RE: **Zoning Atlas Map Amendment – Oleander Oaks –
 PCN: 2433-144-0002-000-3**

STAFF REPORT

**Subject: Rezoning, Site Plan, and Subdivision – Oleander Oaks
Technical Review Project # 21-43900001 & 21-09000001**

**RE : Oleander Oaks Planned Development and Preliminary Plat
TRC No. 21-43900001 & TRC No. 21-09000001**

FPUA Web Map

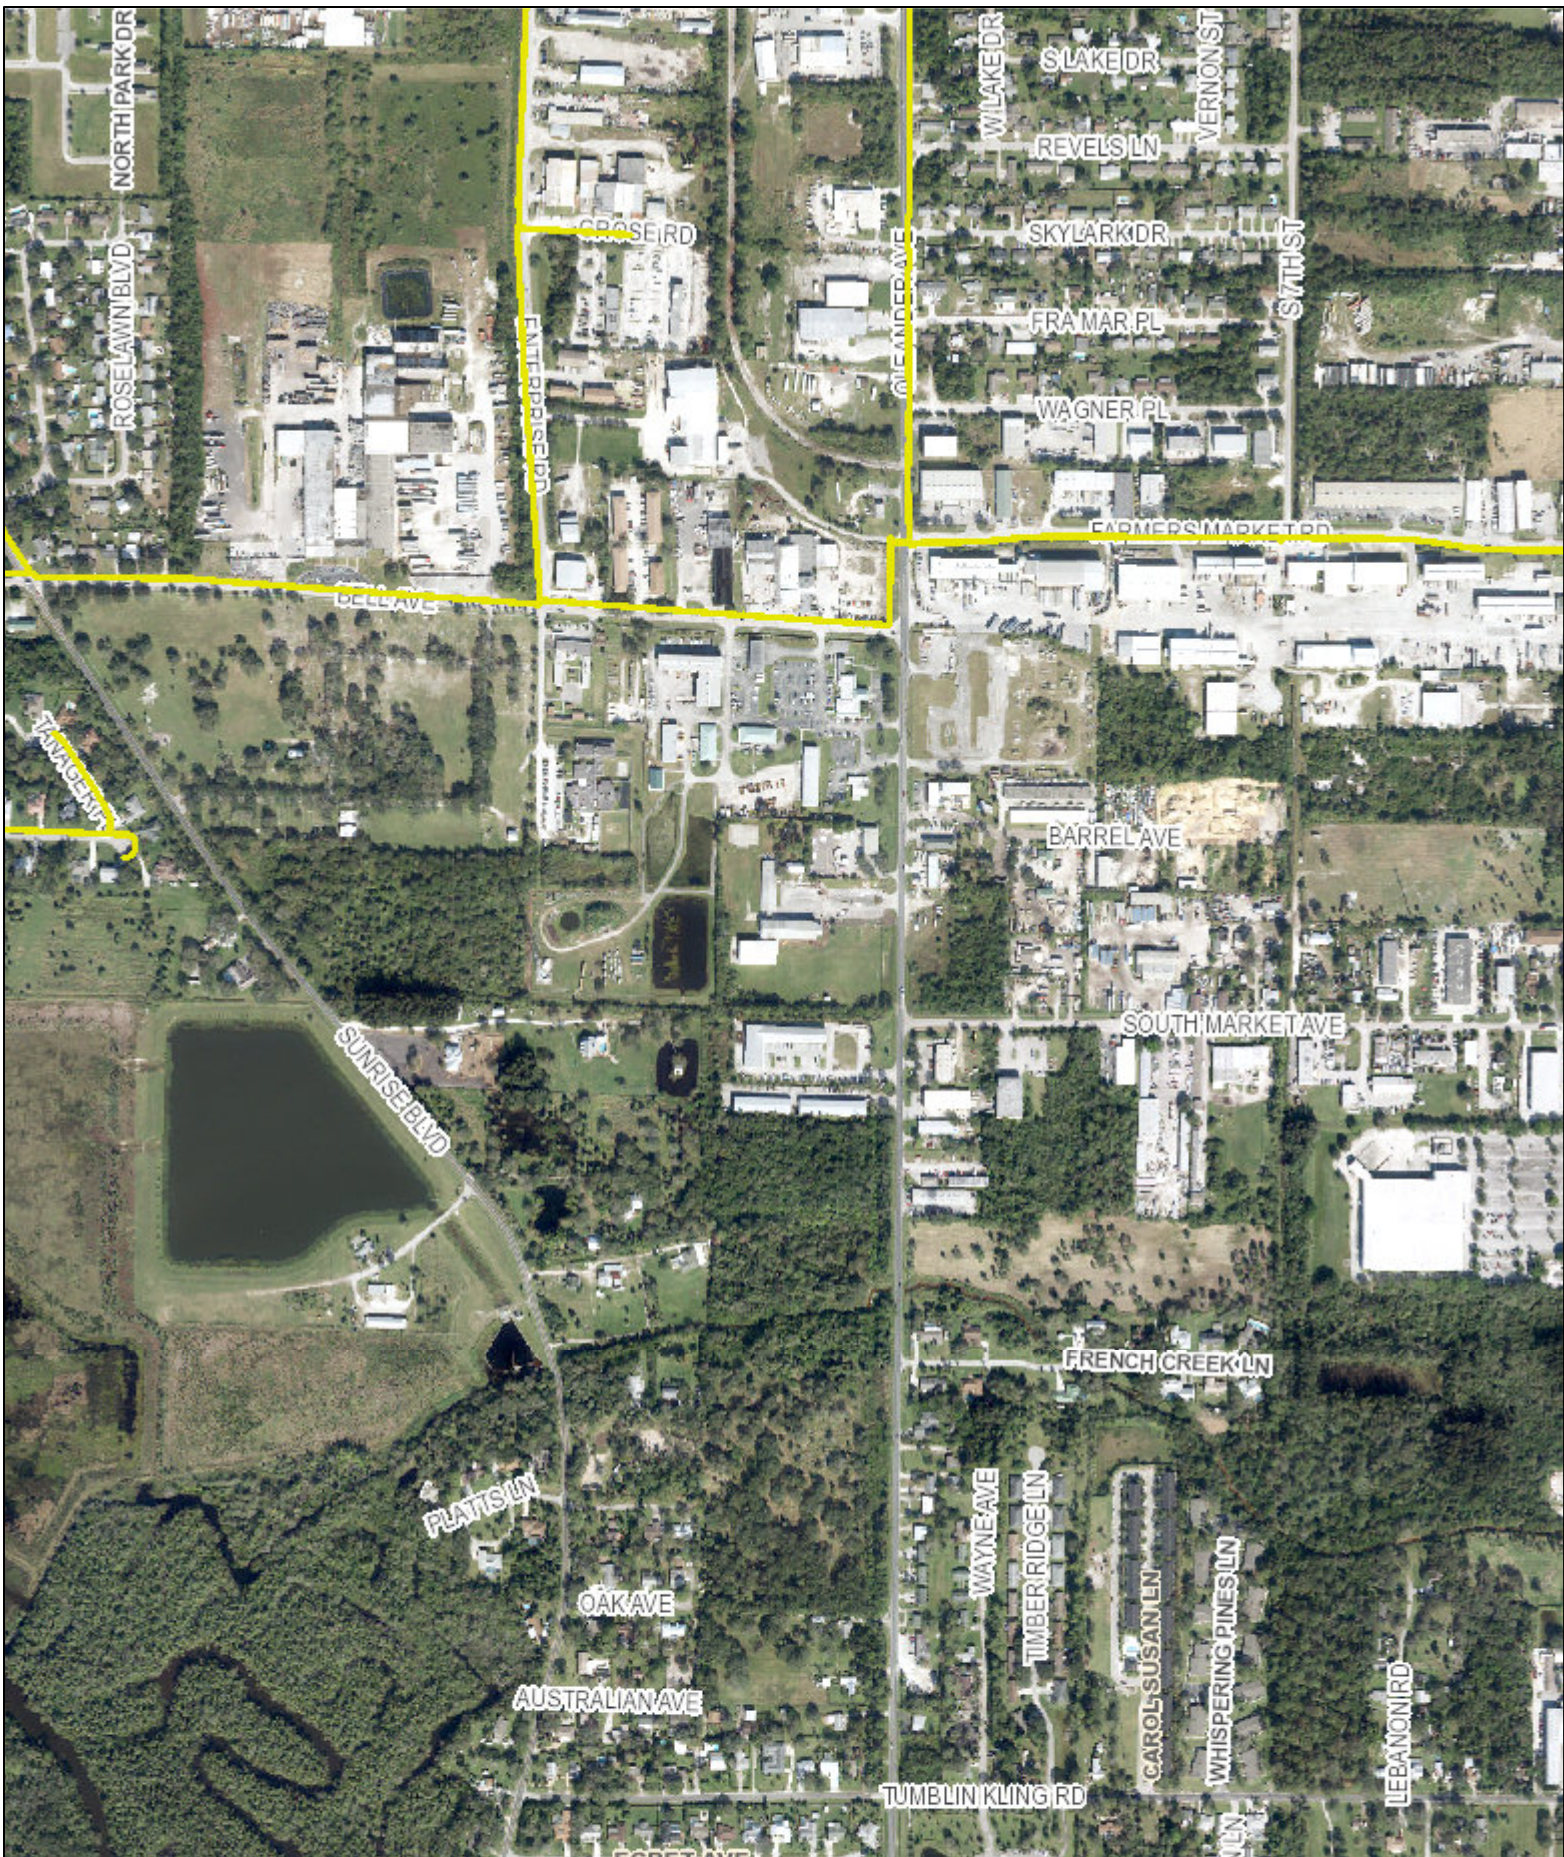
FPUA will require a utility easement for all propose FPUA facilities. Please find attached a copy of the FPUA GIS map (Gas).
